City Hall/Town Hall

December 7, 2015

Del Mar City Council

Project Status

Section with Alvarado House

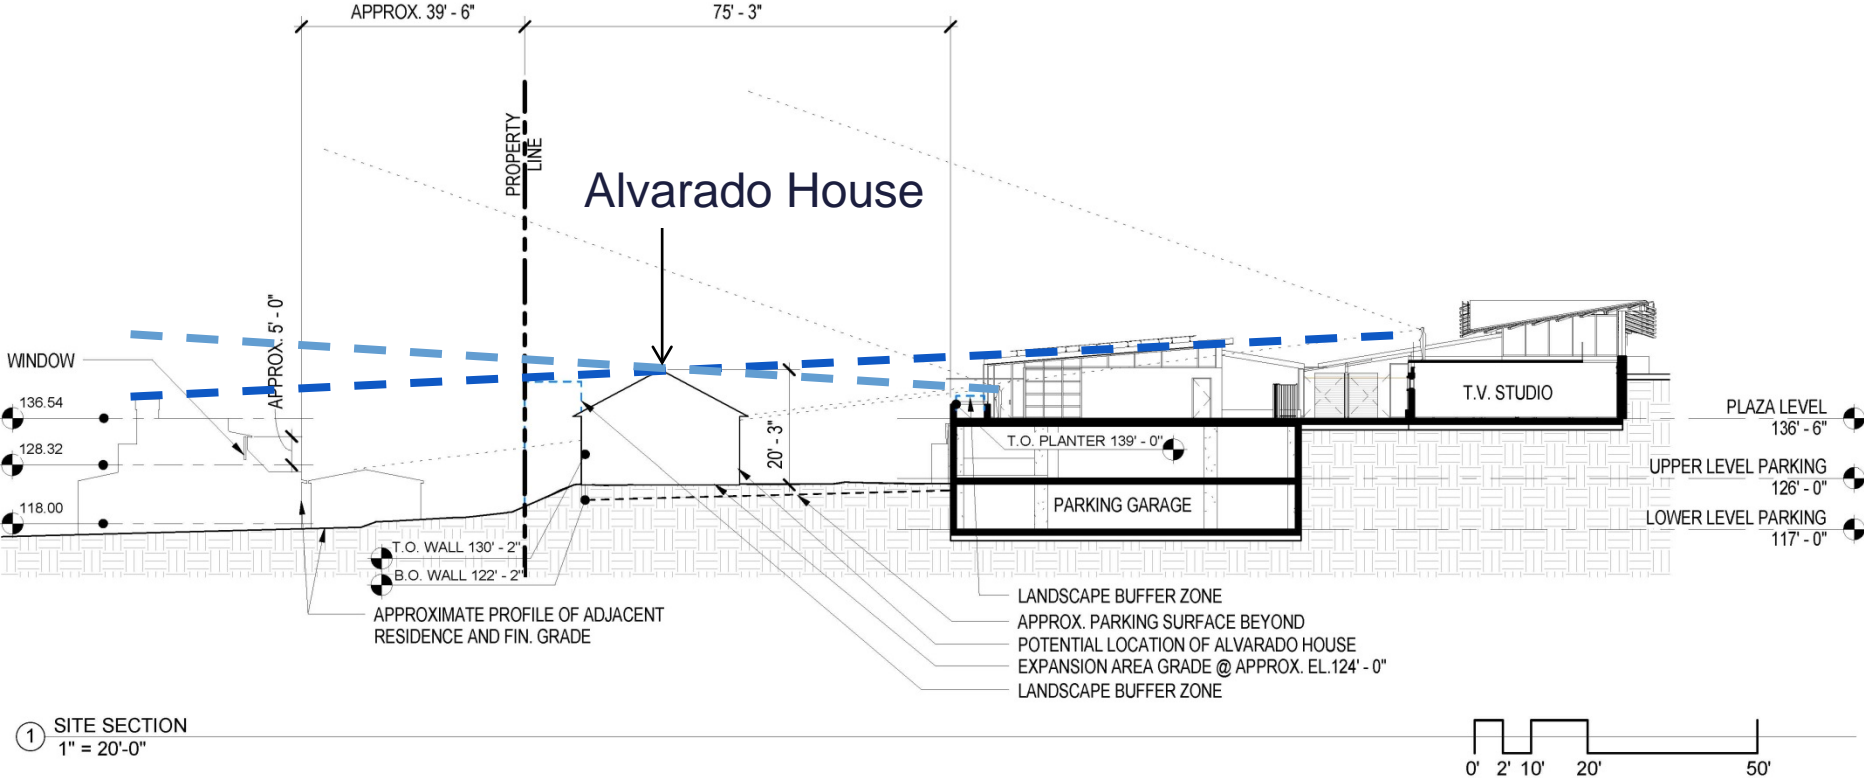
1. Additional Screen Planting along edge of wall
2. Residential front yard style landscape
3. Raise wall to 10-feet tall
4. Locate Alvarado House in Expansion Area C for privacy screen

Parking Access - Alt. 1 & 2

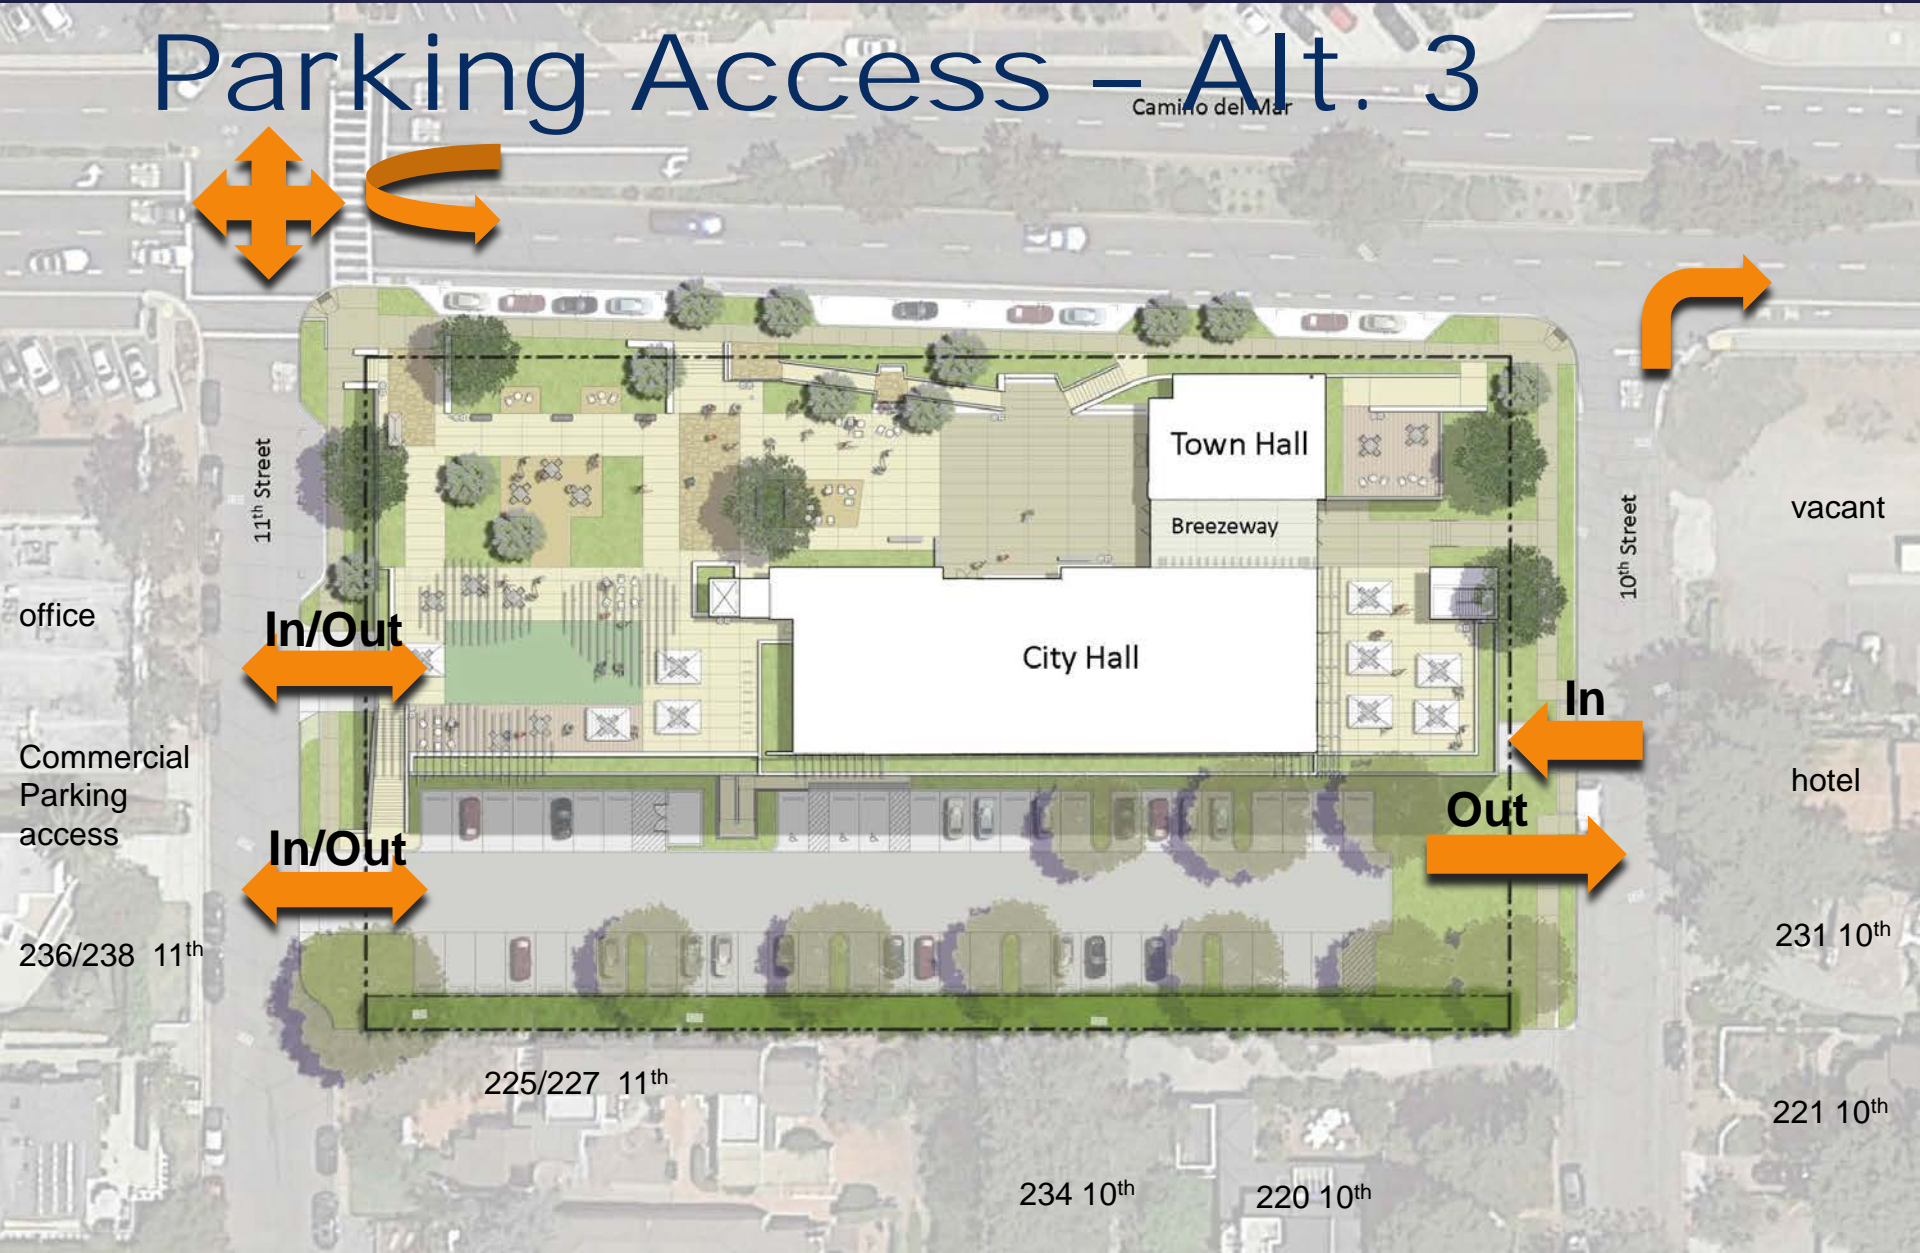
1. Install signage on all egress for right turn only to CDM or
2. Install diverter to force right turns from garage to CDM

Parking Access – Alt. 4A

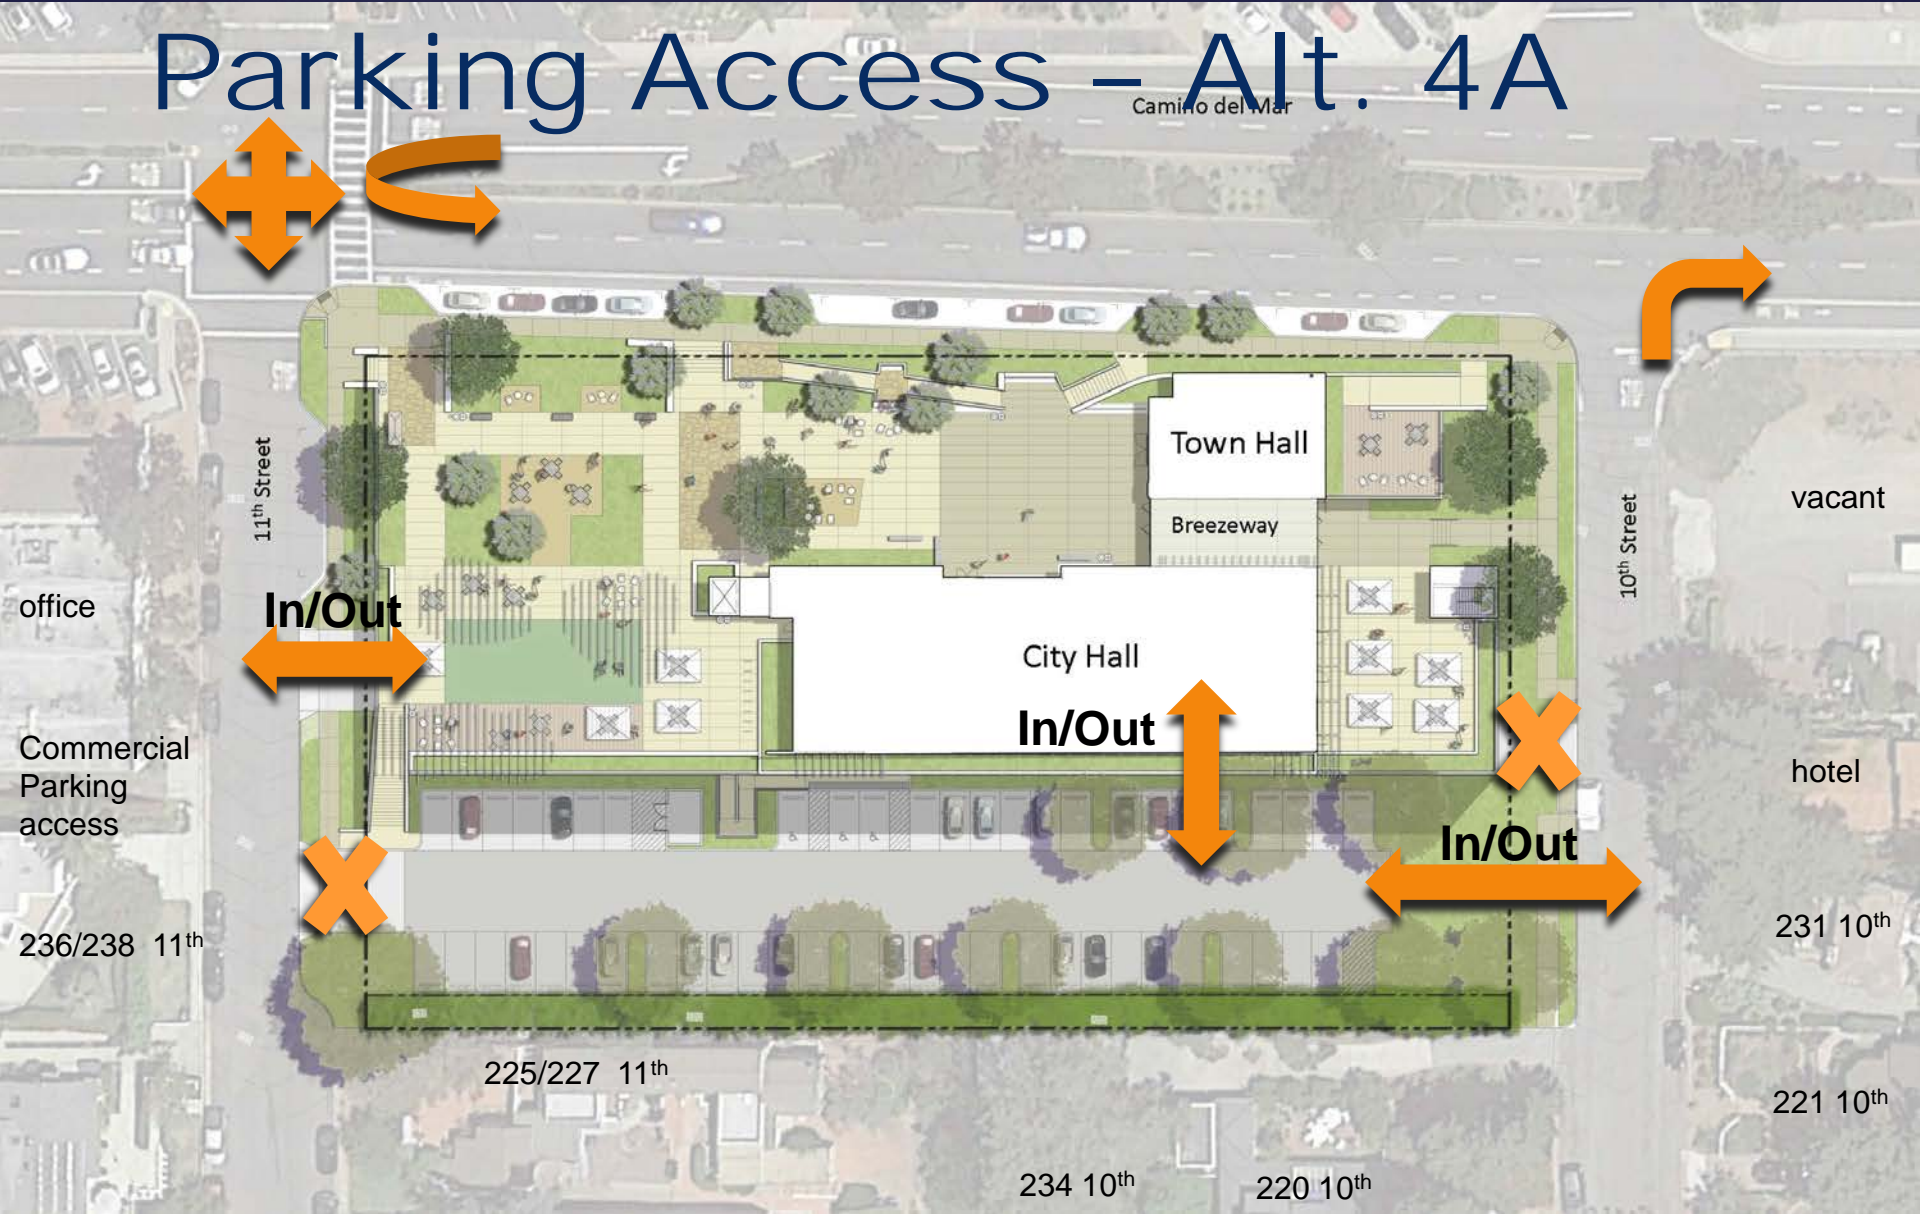
10th Street: Surface lot ingress/egress

11th Street: Garage ingress/egress; possible internal connection

Parking Access – Alt. 4B

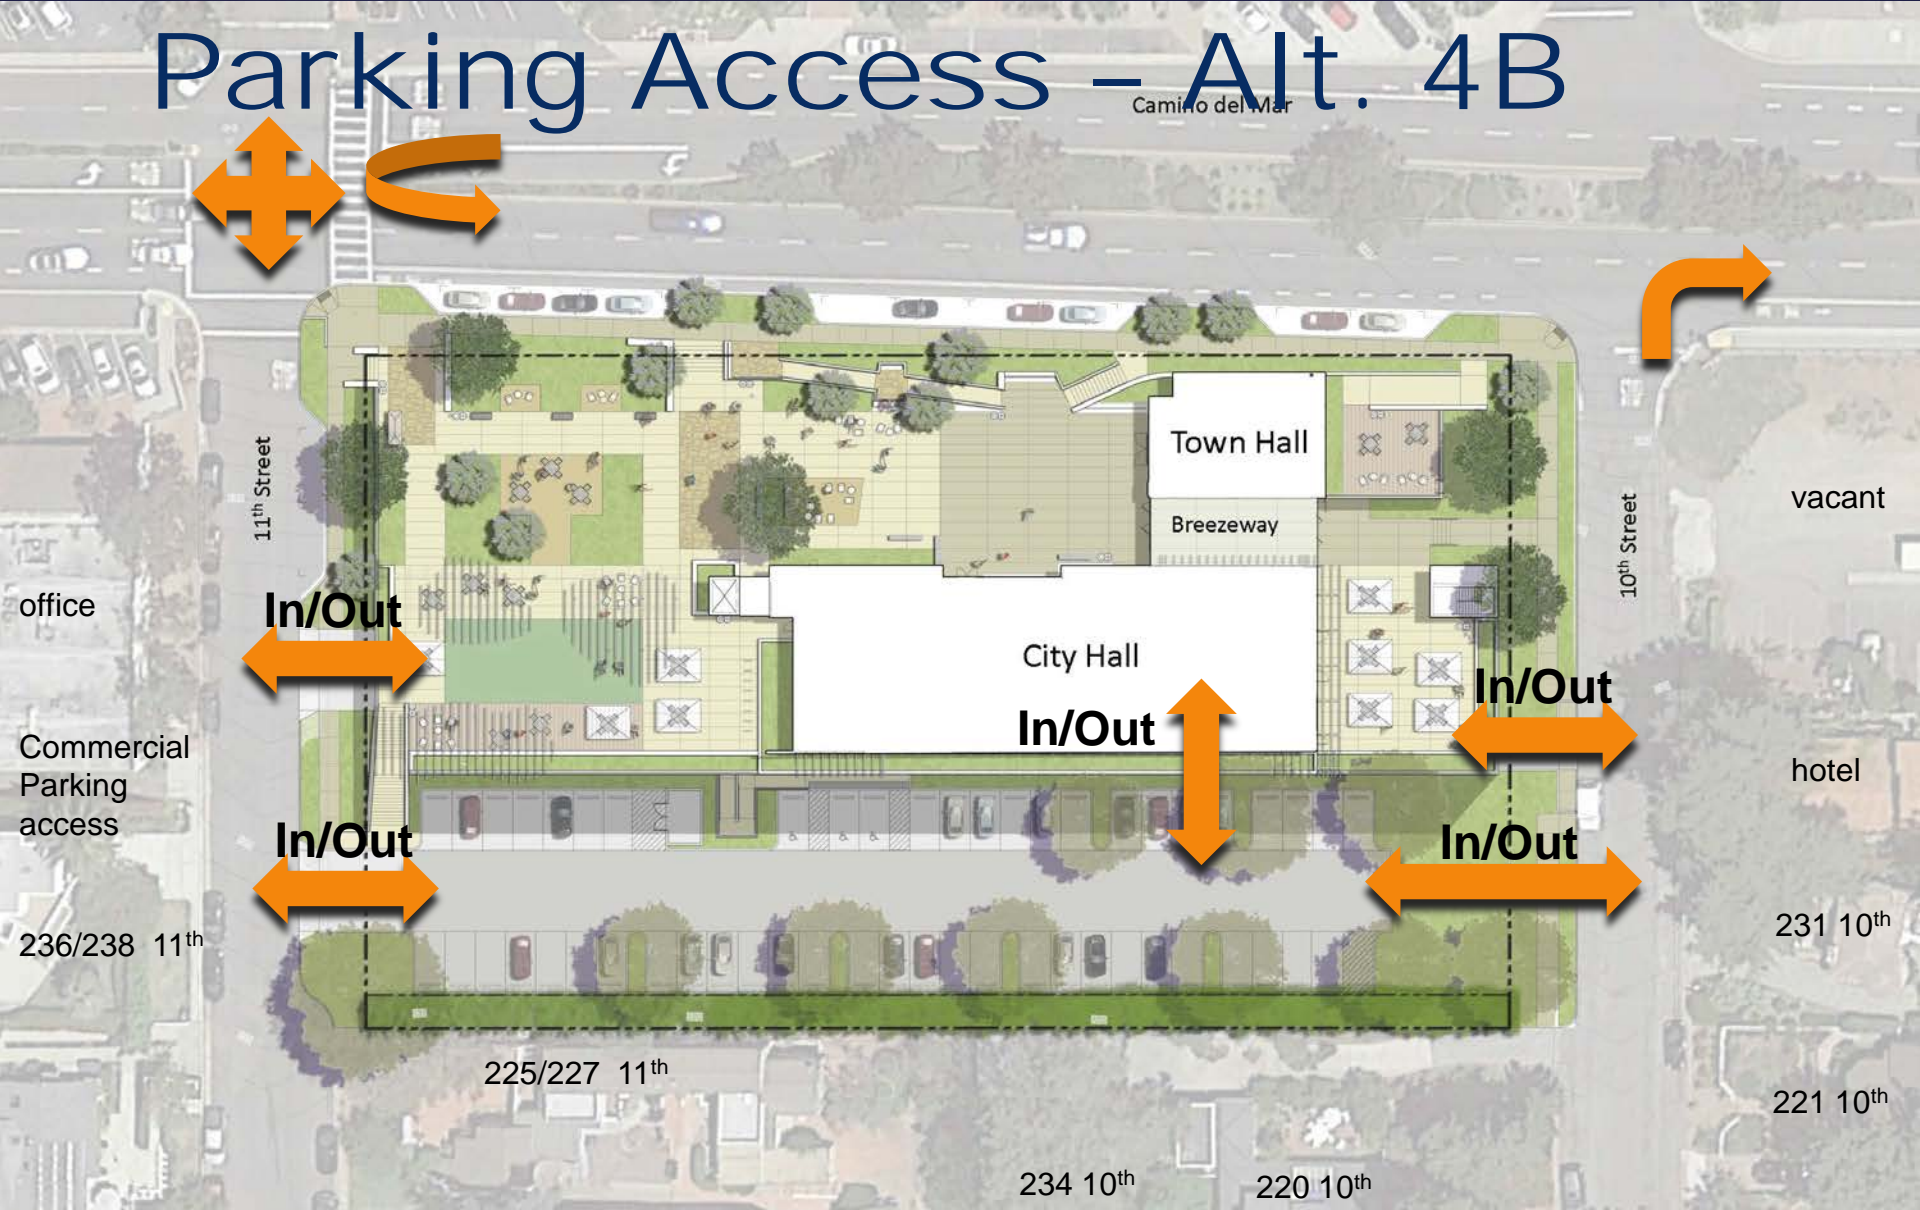
10th Street: Garage and Surface lot ingress/egress
11th Street: Garage and lot ingress/egress; possible internal connection

Parking Access – Alt. 4C

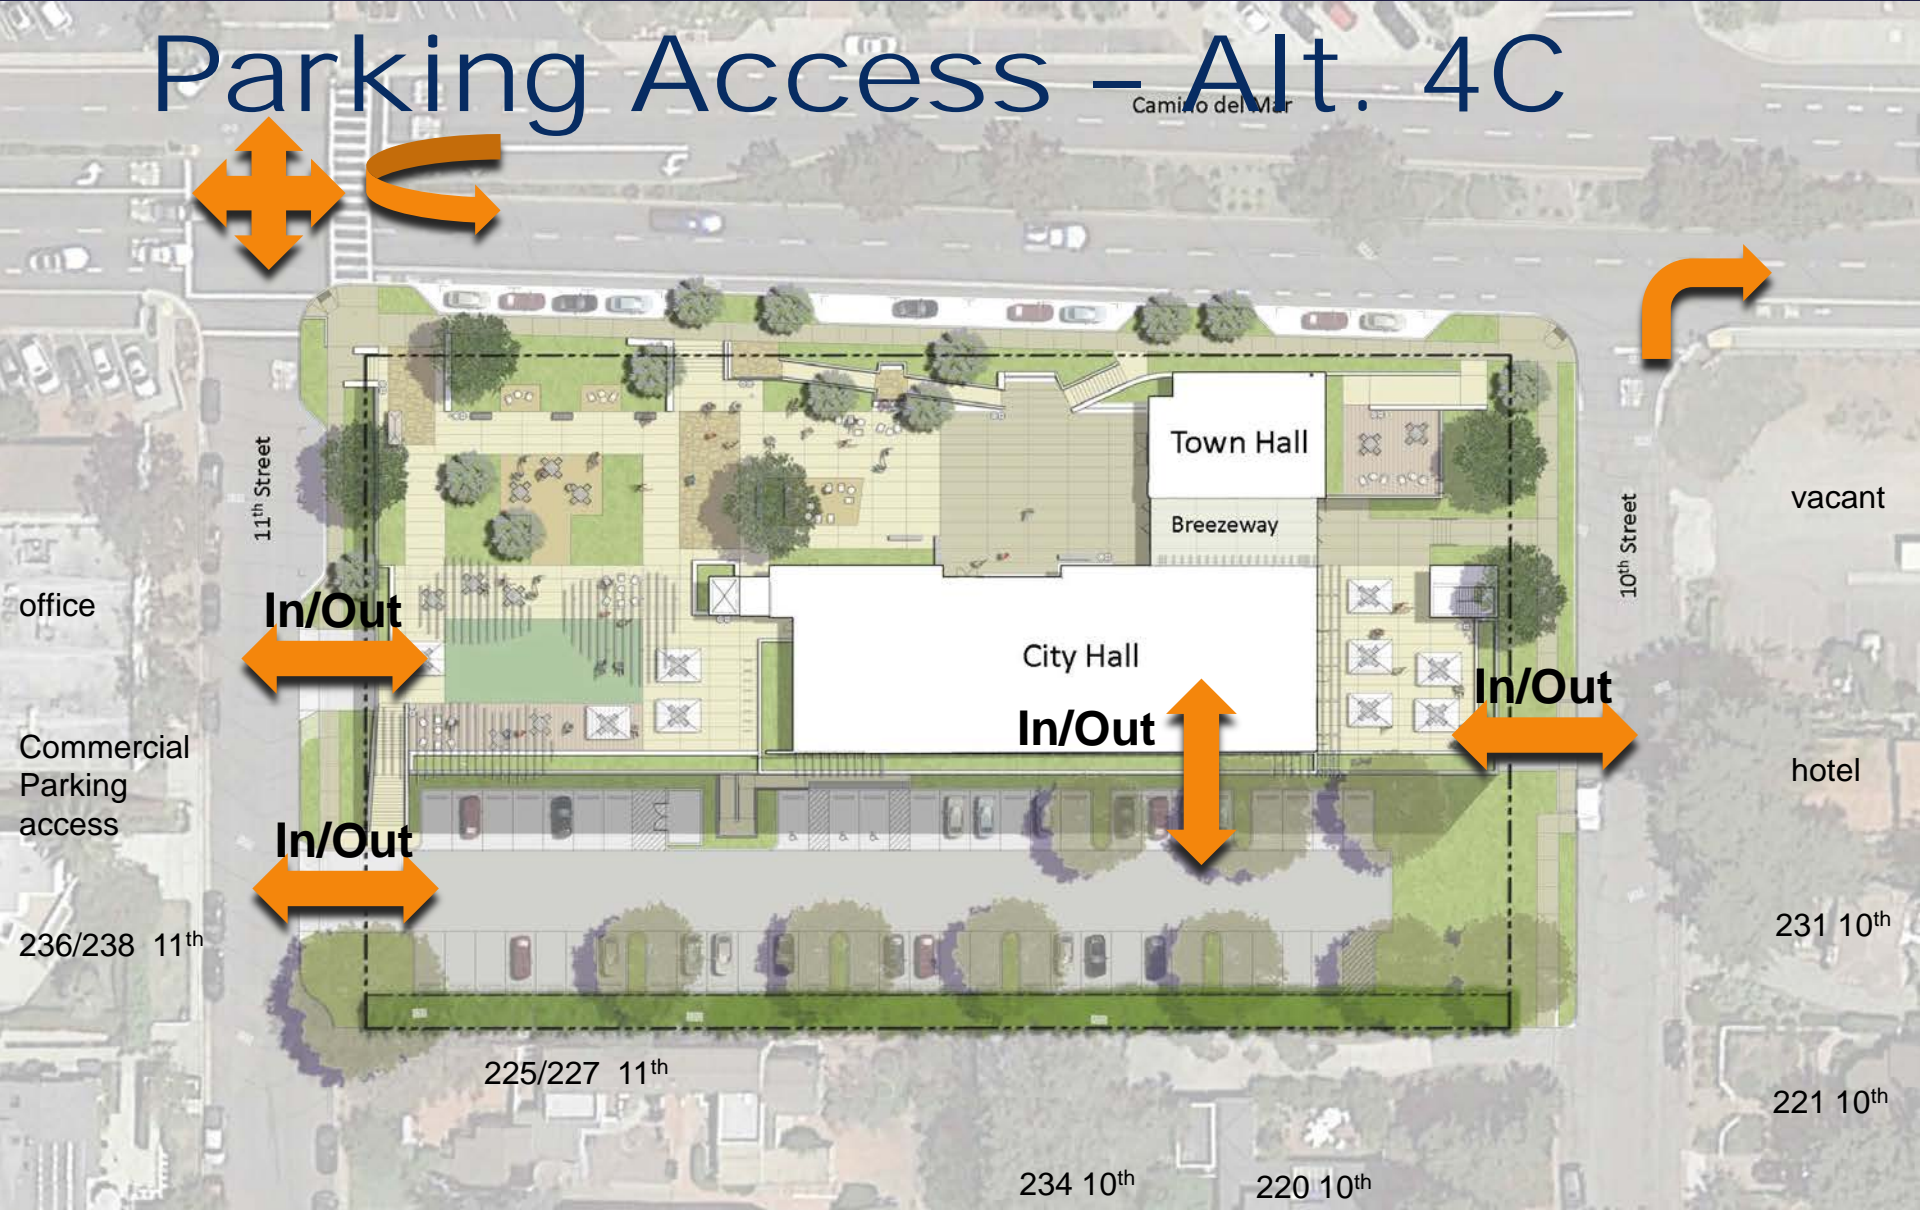
10th Street: Garage ingress/egress

11th Street: Garage and surface lot ingress/egress; possible internal connection
